Work Session IV Agenda

- Review language requested by Planning Board for specific sites
- Discuss additional zoning language, if needed
- Request Planning Board approve Planning Board Draft of Westbard Sector Plan and vote to transmit to County Council

Work Session 12-17-15

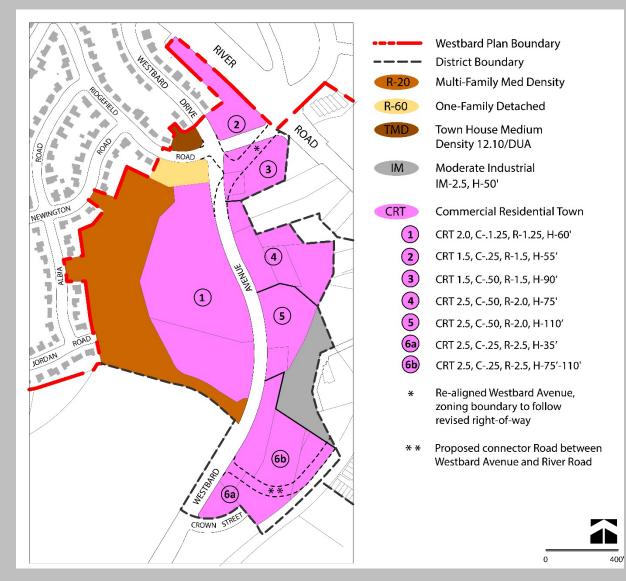
Westbard Avenue District Sites 6a and 6b (Figure 3.1.1 Proposed Zoning Map – Westbard Avenue District) parcels 466, 519, 510 and 576, - Heights of buildings to range between 35 feet at the south end of the site to 110 feet at the north end. Height transitions to be gradual, avoiding abrupt changes in height. The proposed connector street between Westbard Avenue and River Road to be located as far north as practical, and the heights south of this road to be a maximum of 35 feet. The height transitions to be detailed and illustrated more fully in the Westbard Sector Plan Design Guidelines.

- Westbard Avenue District Sites 6a and 6b (Figure 3.1.1 Proposed Zoning Map Westbard Avenue District) parcels 466, 519, 510 and 576, - At the time of redevelopment, residential portions of the site greater than 35 feet in height must provide a minimum of 25% affordable housing units, including a minimum of 15% moderately priced dwelling units and 10% workforce housing units.
- <u>The gas stations that exist on Parcels 128 and 357 on Westbard Avenue are</u> <u>appropriate uses, and it is anticipated that they will continue to be appropriate</u> <u>uses for these sites.</u>

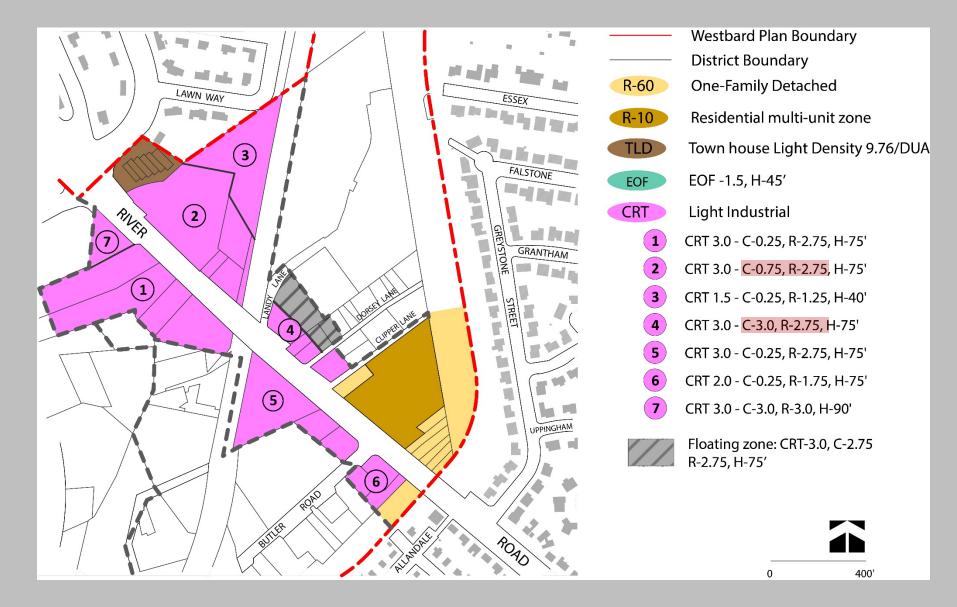
Pages 68, Revise bullets under **3.2.1 Land Use and Zoning:** first bullet: Maintain the maximum heights from 35 feet and to a range of 40 feet to 75 <u>90</u>feet.

fourth bullet: Change the height from 50 feet to 40 feet.

<u>River Road Corridor Site 2 (Figure 3.2.1 Proposed Zoning Map – River Road Corridor),</u> parcels 029, 055, 082 and 109 - the proposed 75 feet of height, should only be allowed if future development includes the priority benefit incentive of a recommended green space along Willett Branch (See page 70: Community Open Space along Willett Branch). Future development should be placed closer to the Capital Crescent Trail, where feasible. This condition assumes assemblage of sites 2 and 3.

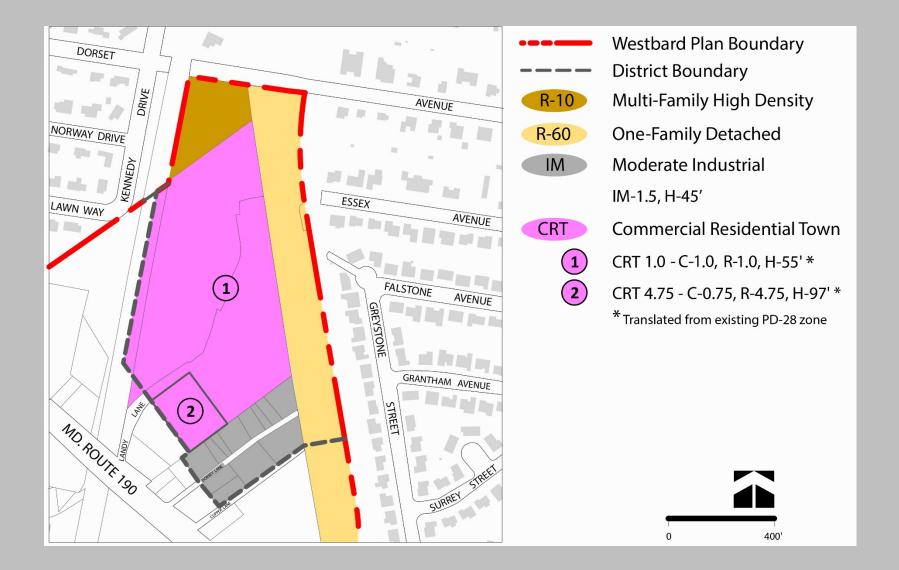
If site 2 (in figure 3.3.1), parcel 112, develops under the new zoning rather than the previously approved PD zone, any new application for development involving the same uses as approved in the Development Plan, and its PD zoning must incorporate the approved binding elements, as conditions of the preliminary plan or site plan, as appropriate.

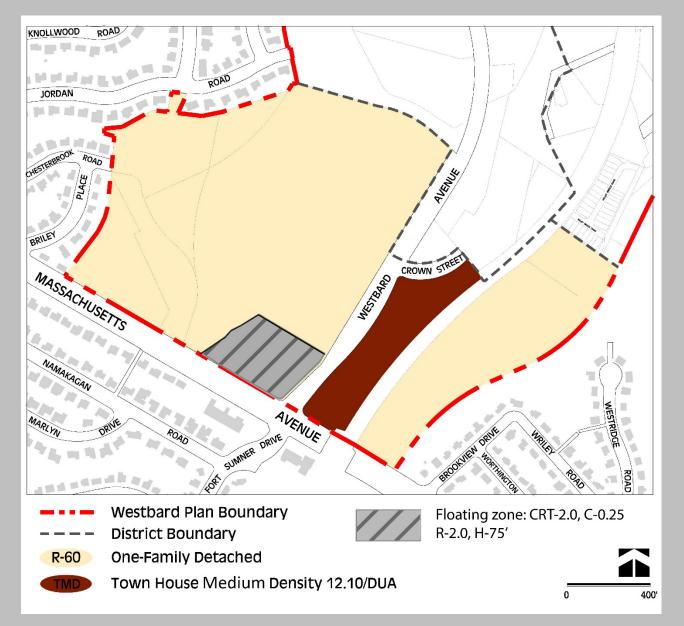
Page 82, under Land Use and Zoning, add new paragraph:

The existing Little Falls Library and Site is owned by the Montgomery County Department of General Services. In order to accommodate the demand for affordable housing in the Westbard Sector Plan area, the Plan recommends the consideration of a CRT floating zone for this R-60 zoned property. As a condition of redevelopment under this floating zone recommendation, the project must involve a public/private partnership that includes a higher percentage of affordable housing than mandated by law, and the co-location with a public facilities, such as a preserved or rebuilt library.
